# Land Use and Planning Committee AGENDA

# Monday, September 20, 2021, 6:15 p.m.

Corporate report dated September 20, 2021 from the Director of Planning and Development Services titled "Zoning Amendment Bylaw and Major Development Permit – 15631 Russell Avenue & 1509, 1529, 1539, 1549, and 1559 Maple Street (ZON/MJP 18-008)".

Figure 6: Shadowing image illustrating breaks in the blocks of townhomes and massive relative to nearby development

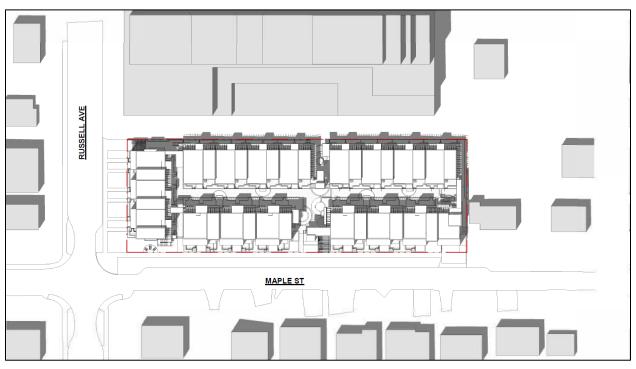
• Ground-oriented access to the units along Russell Avenue and Maple Street helps to animate the streetscape while providing for some degree of passive surveillance (22.8.1.d). Further, blocks of ground-oriented townhome units fronting abutting streets are limited to a maximum of six contiguous units providing for adequate breaks in the massing of development (22.8.1.f & l) as well as through-block walking connections (22.8.2.b) (see Figure 6).

Figure 9: Design considered by the ADP Panel

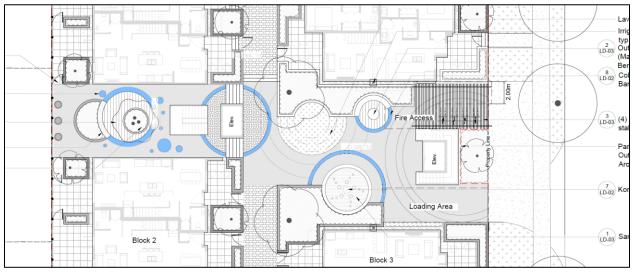
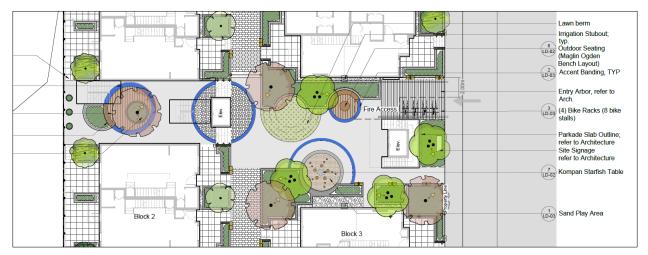
- The southwest portion of the development, immediately adjacent to the Altus building along Russell Avenue, has been enhanced with an entry arbour, flanking planters and animated paving patterns.
- The ADP acknowledged the use of circles in the central courtyard and suggested that the design be simplified to reduce the number of circles incorporated into the design. Figure 9 below illustrates the design considered by the Panel and Figure 10 illustrates the revised design; note that the aforementioned loading area is shown in Figure 9.

Figure 10: Revised Design
